Subject: Consultation on revision of standard for GR “Lightning and Surge Protection of Telecom Sites, TEC 66130:2024”-reg.

TEC 66130:2025

(Supersedes No. TEC 66130:2024)

लाइटनिंग एंड सर्ज प्रोटेक्शन ऑफ टेलीकॉम साइट्स
LIGHTNING AND SURGE PROTECTION
OF TELECOM SITES

FIGURE 2

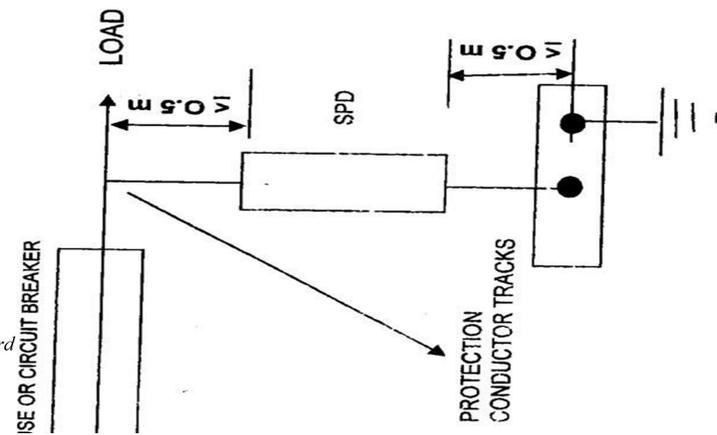
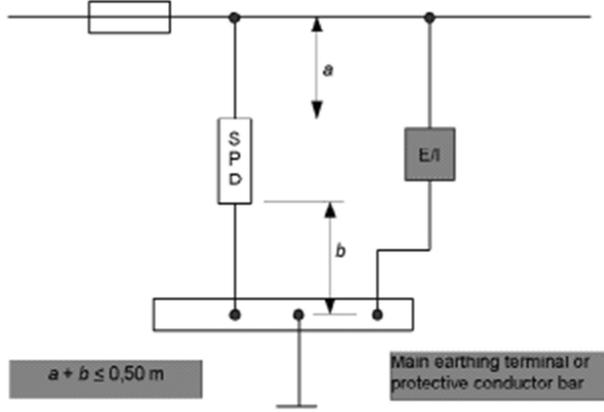
a+b ≤ 0.50 m (meter) as per IS 732:2019 as amended time to time.

FIGURE 3

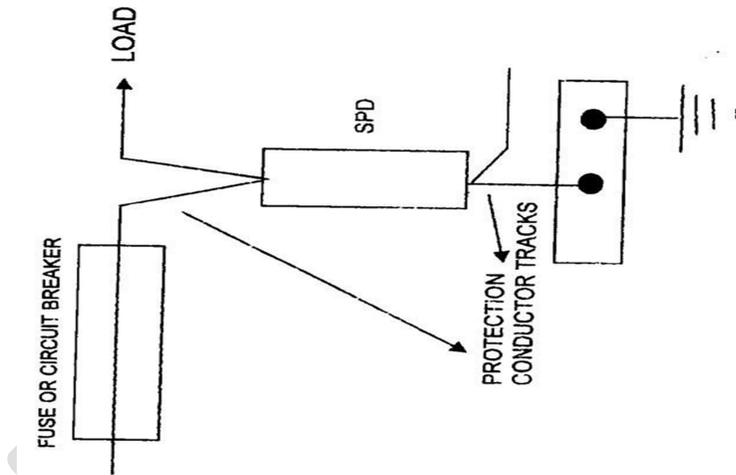
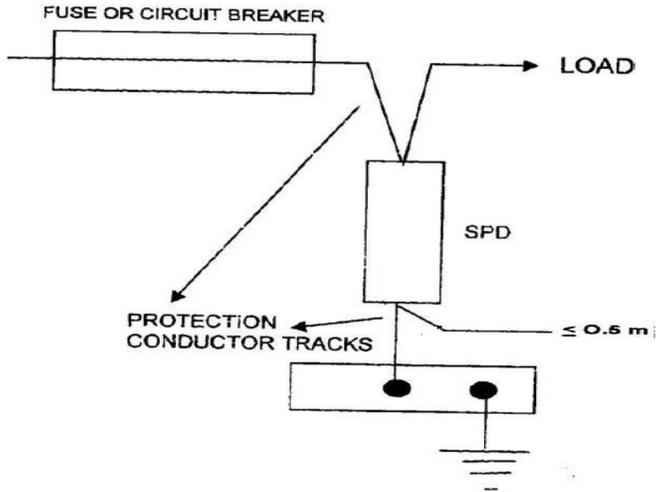
Cable length as per IS 732:2019 as amended time to time.
